Access Compliance Report

Public Rights-of-Way

(Curb Ramps)

Intersection ID: 10020275	Main Street: AYRSLEY_TOWN_BV	Cross Street: N/A	Location: S
ADA ID: ED209FBC9697	Ramp Type: BlendTrans1	Initial Pass/Fail: Pass	Overall Compliance: No
Severity Score: 0.25			
Codes/Mitigation Info/Possible Solution		Field Measurements/Component Compliance

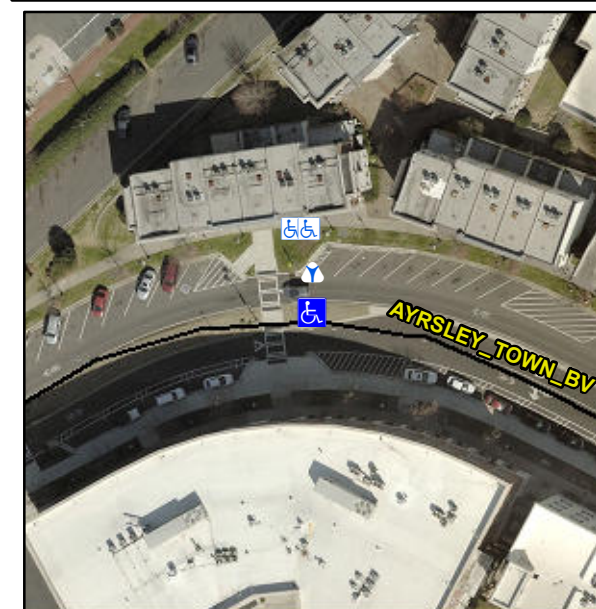
Not Found, R304.5.3

Yes	Ramp inside XWalk1?	Yes	N/A	Ramp inside XWalk2?	N/A
	Road Slope (%)	2.7		Clear Space?	Yes
	Road X Slope (%)	2.4	N/A	Clear Space to XWalk (in)	N/A
Yes	Any Obstructions?	No	Yes	Storm Grate/Utility Hazard?	No
	Obstruction Type			Storm Grate/Utility Type	
			N/A		N/A
			Yes	Surface Condition? (G/P)	Good
			No	Curb Slope (%)	6.5

Remove & Replace Curb Slope and Extend Ramp. Remove & Replace Gutter.
